CITY OF GARDEN CITY

STAFF REPORT

File Number: SUBFY 2024 - 0005, Zhanna Place Townhomes

For: Preliminary Plat and Planned Unit Development
A 10 residential lot and 1 common lot subdivision

Picture 4

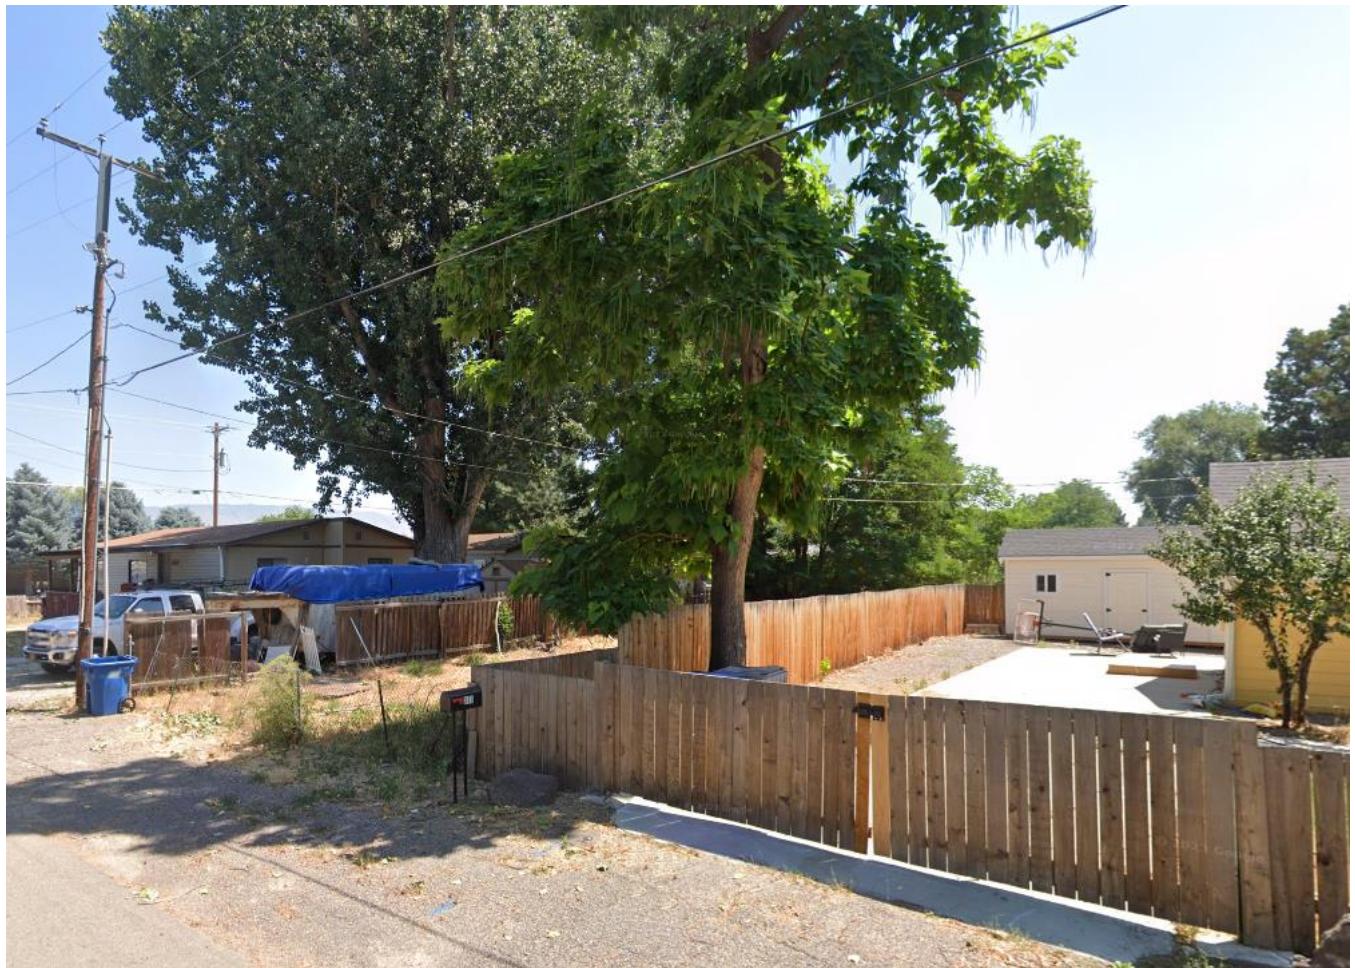
<u>8-4A-4 Outdoor Lighting</u>	PZ/DRC/CC	Compliant as Conditioned	This proposal does not identify any outdoor lighting. Any future outdoor lighting will be required to be in compliance with code at the time of development.
<u>8-4A-5 Outdoor Service and Equipment Areas</u>	PZ/DRC/CC	Compliant as Conditioned	This proposal does not identify any outdoor service equipment. Any future outdoor service equipment area will be required to be in compliance with code at the time of development, and will be reviewed during the building permit and prior to certificate of occupancy.
<u>8-4A-7 Stormwater Systems</u>	PZ/DRC/CC	Compliant as Conditioned	A draft condition of approval has been provided requiring that the stormwater systems be built in compliance with provisions of 8-4A-7 and other stormwater ordinances and policies.
<u>8-4A-8 Utilities</u>	PZ/DRC/CC	Compliant as Conditioned	<p>All existing and proposed utilities shall be underground.</p> <p>There are overhead utilities running along the entire frontage of the property on the 313 E 48th Street. (see Picture 4)</p>
